FOR CONTRACT NO.: 02-2E5104

INFORMATION HANDOUT

FOUNDATION REPORT AND ADDENDUM

ROUTE: 02-SHA-299-4.3/5.5

Appendix 1. Modified Excavation and Backfill Schematic

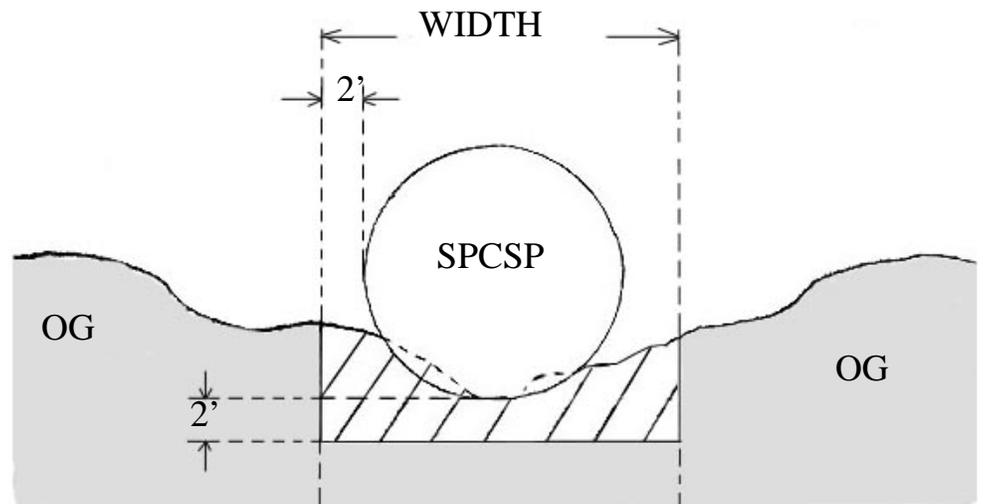
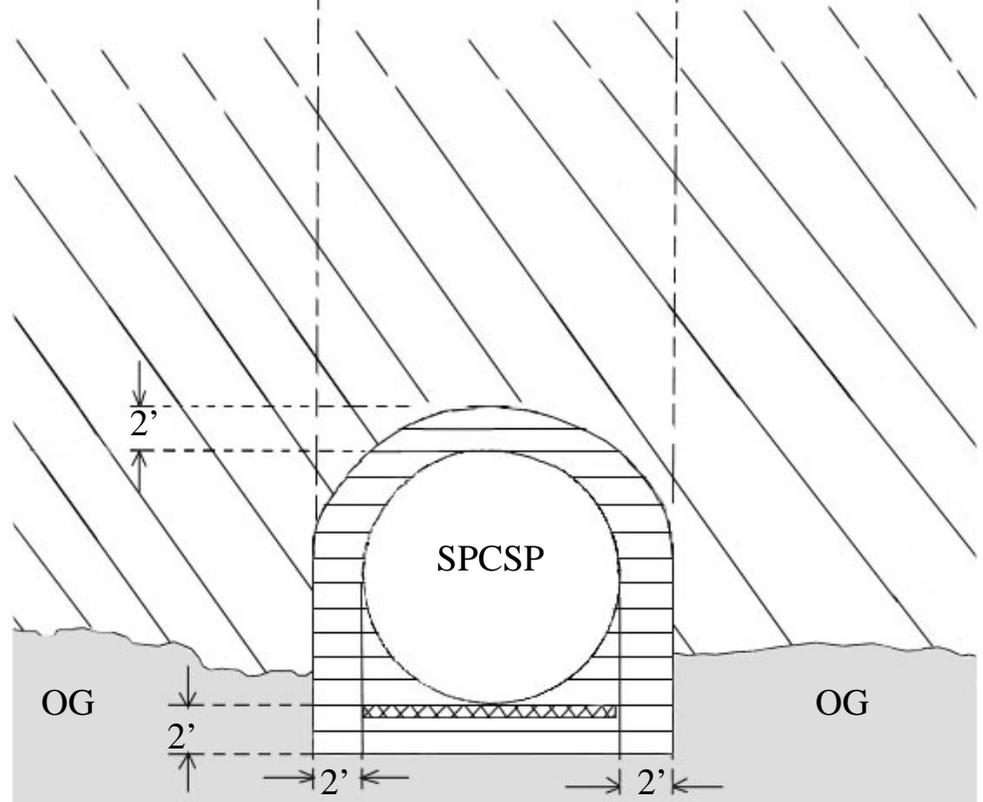
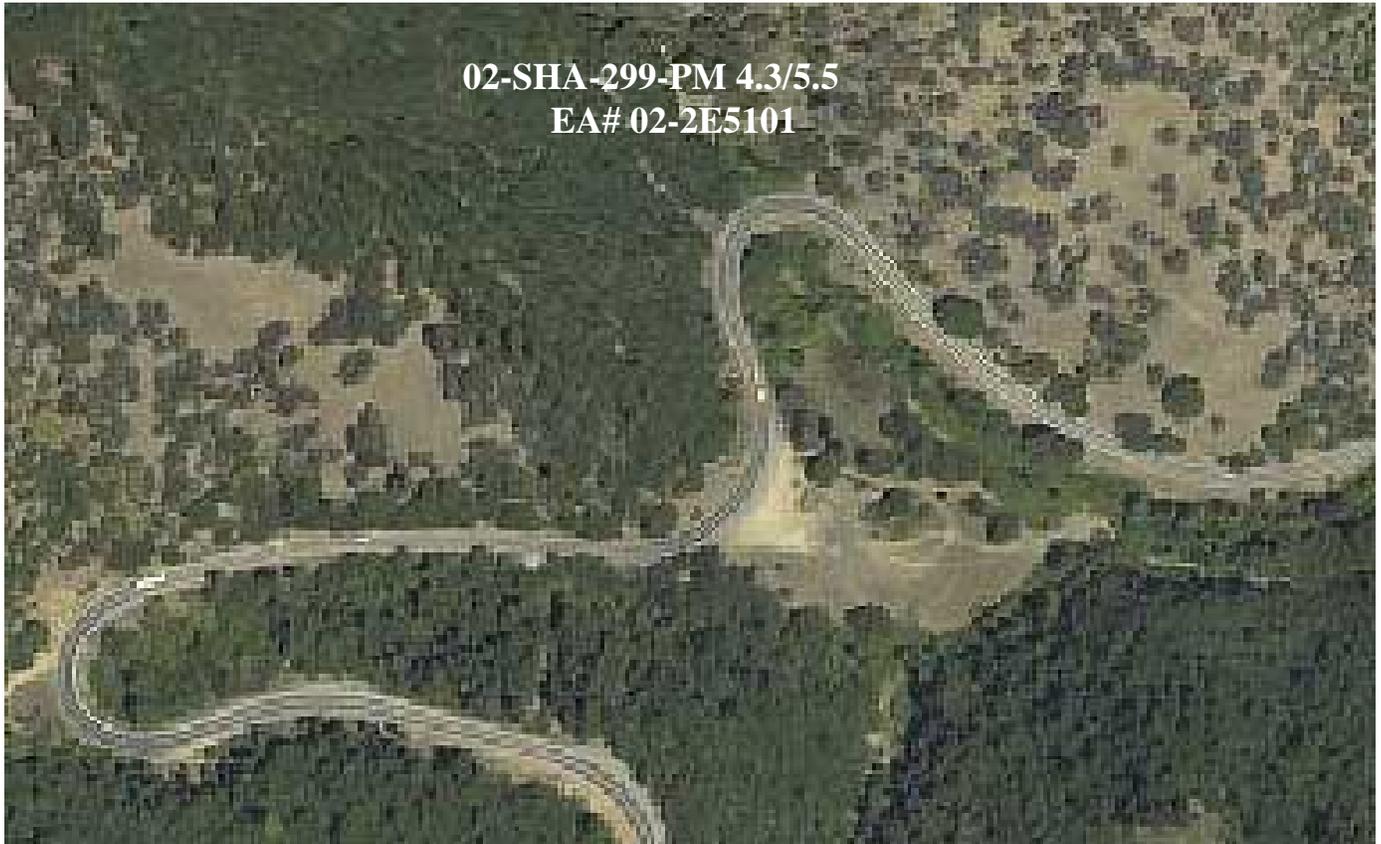
Recommendations provided in the initial FR regarding the breadth of structural backfill relative to the pipe diameter (three times the pipe diameter) were based on recommendations given in the Handbook of Steel Drainage and Highway Construction, which is published by the Corrugated Steel Pipe Institute. The amended recommendations provided herein call for structural backfill to extend 2 ft to the sides of the pipe as shown in the drawing in Appendix 1.

The initial recommendations also called for 4 ft of structural backfill beneath the bottom of the pipe. This 4-foot section was intended to remove any potential risks created by differential

settlement in the founding soil caused by undulations and variations in the topography of the bedrock below the soil. Based on conversations with some SPCSP manufacturers and guidelines in the Handbook of Steel Drainage and Highway Construction, OGDN believes that settlement that creates up to a 0.5% deflection per unit length is considered acceptable. Based on this, our Office has reduced the 4-foot section of structural backfill to a 2-foot thick section. This is depicted in the drawing in Appendix 1.
